REQUEST FOR INFORMATION **DATE:** August 04, 2016 **NO.:** RFI-234

Project Name: 15051-Webster University Interdisciplinary Science Building Project No.: 15051

Subject: Storm Drain Conflict with Structural Beam

P0101.B

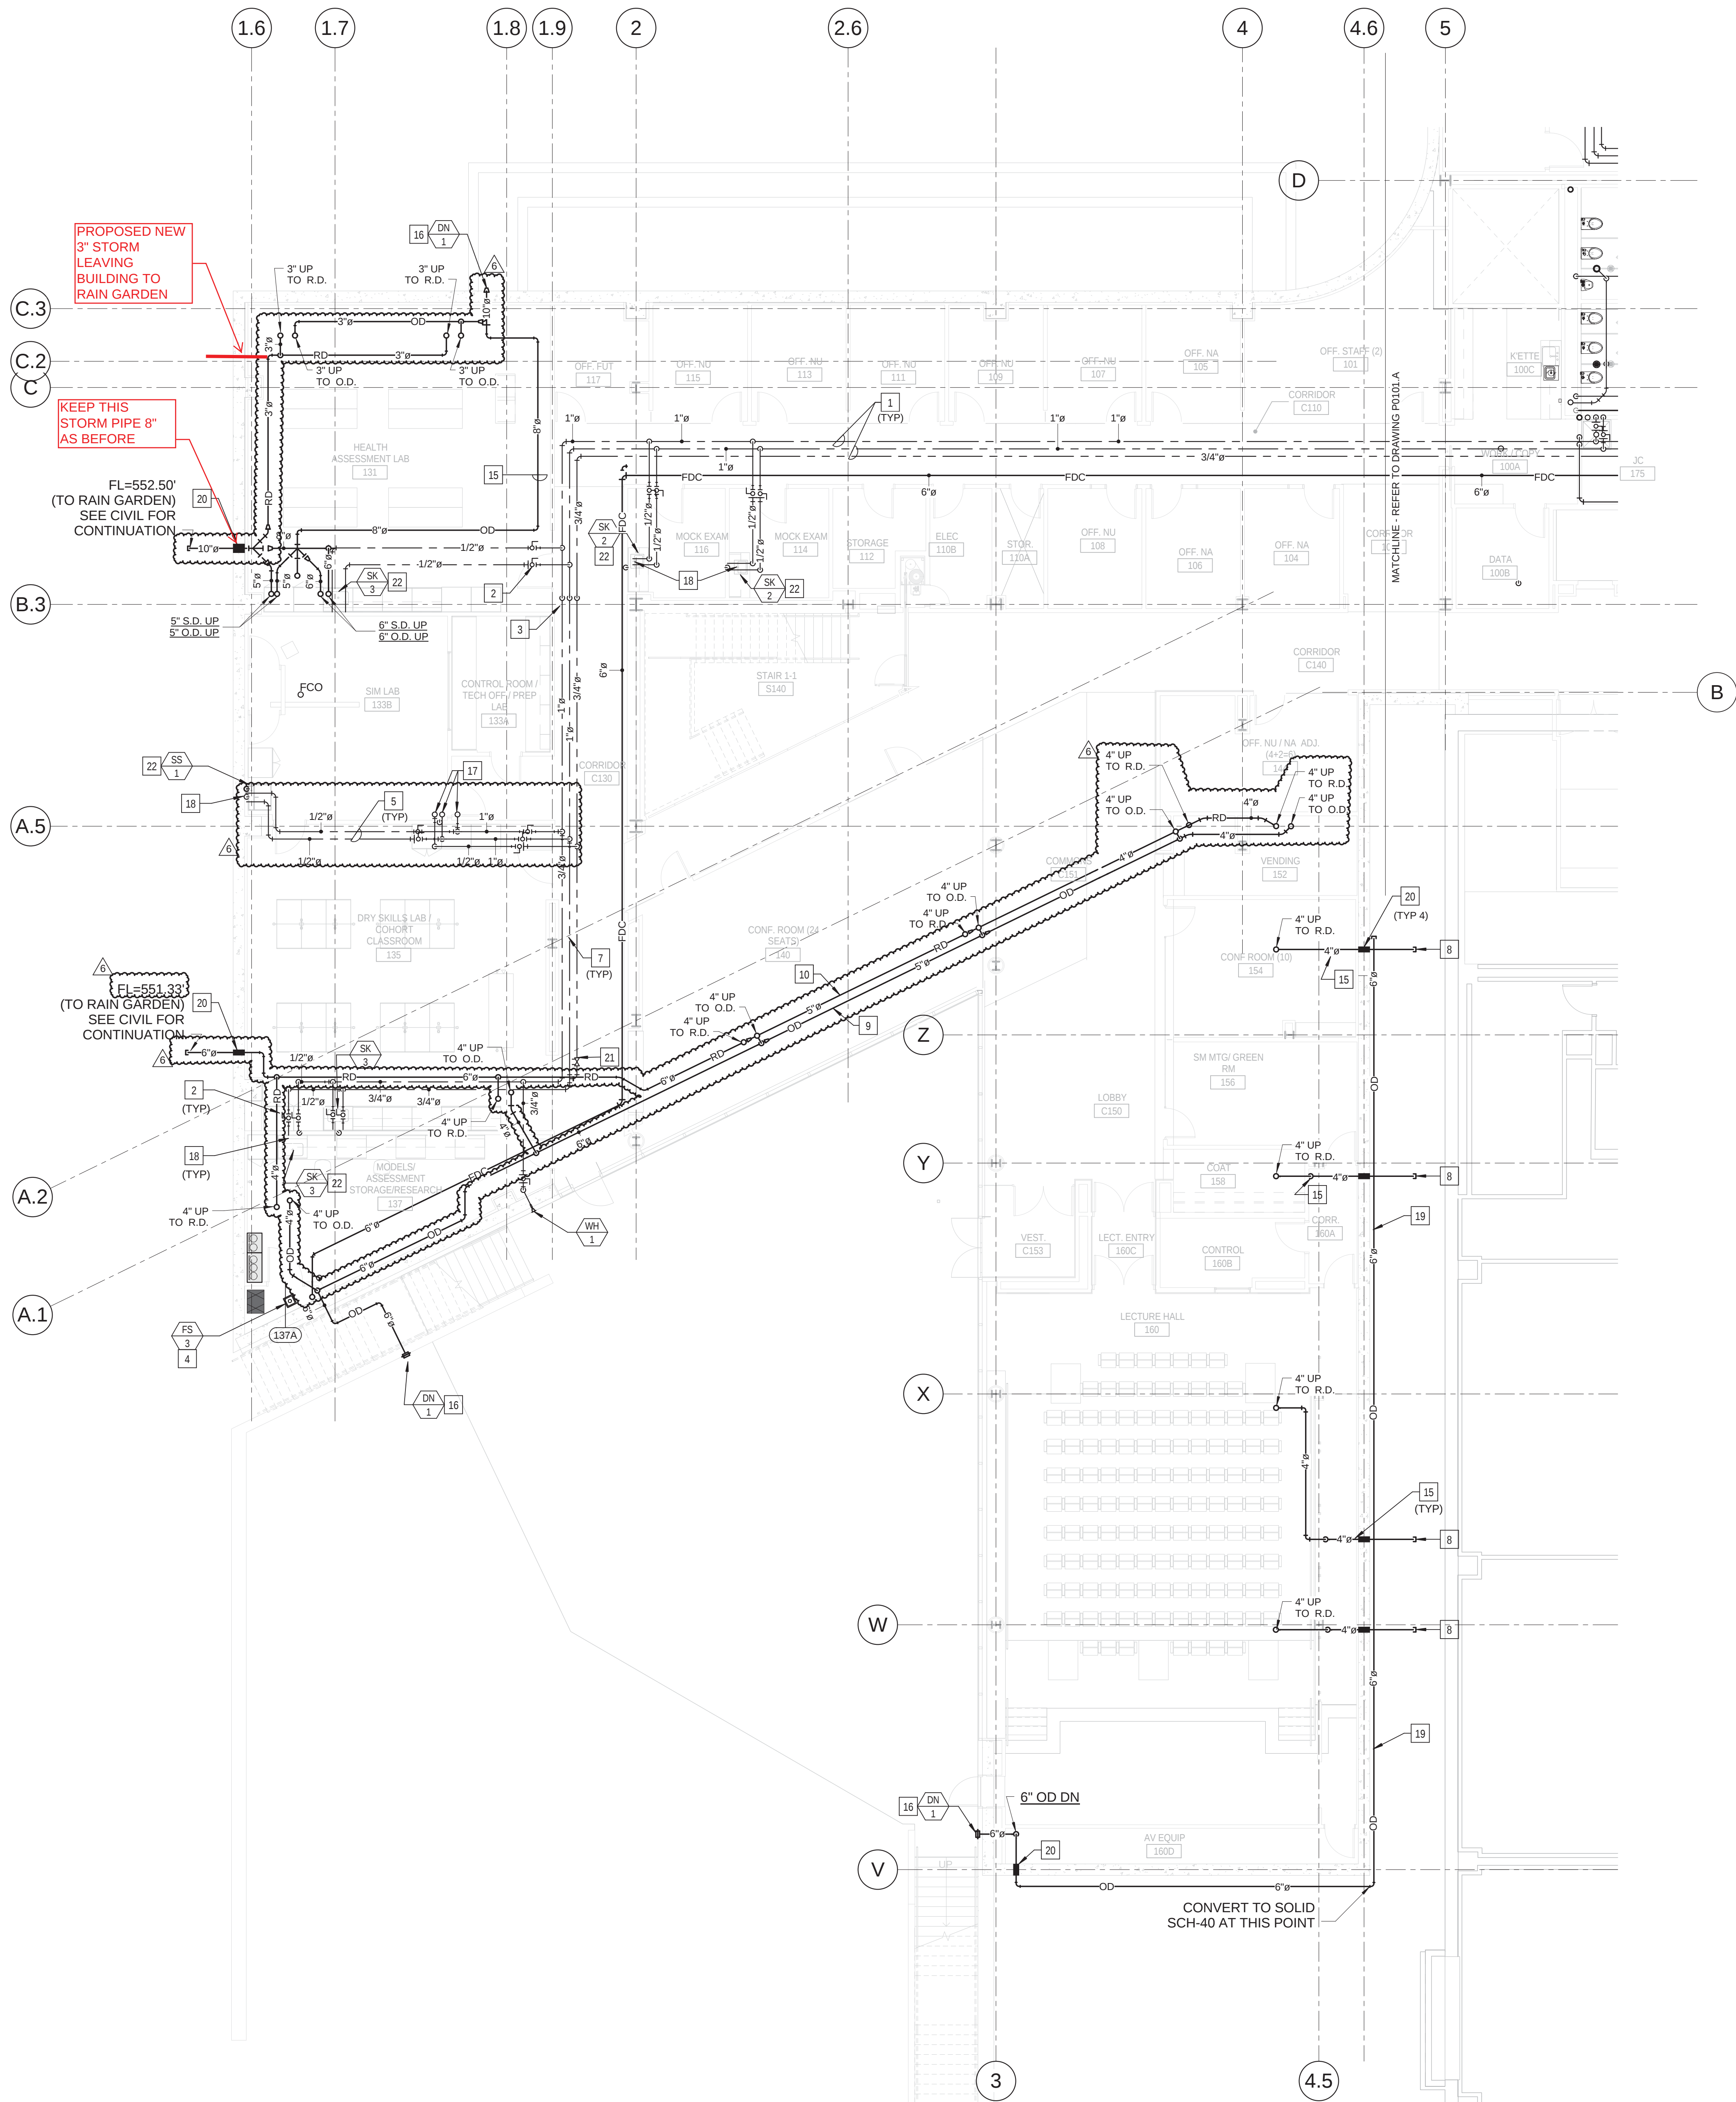
In ASI 13 page P0111.A there were 2 area drains added, with 3" storm piping extended from the new 10" storm pipe passing through foundation on 1.6 line north of B.3 This places the added 3" storm pipe into the bottom of the W27x94 beam at C line by 2". A new hole will be needed to be cored through 1.6 line to increase from the 8" to 10" line so one possible option is to keep the 8 " storm line as is and core a new hole for the added 3" storm (see attached markup). This change could then be instituted into the civil package to eliminate the conflict within the building.

Please advise preferred method

This will be addressed in an upcoming ASI #022.
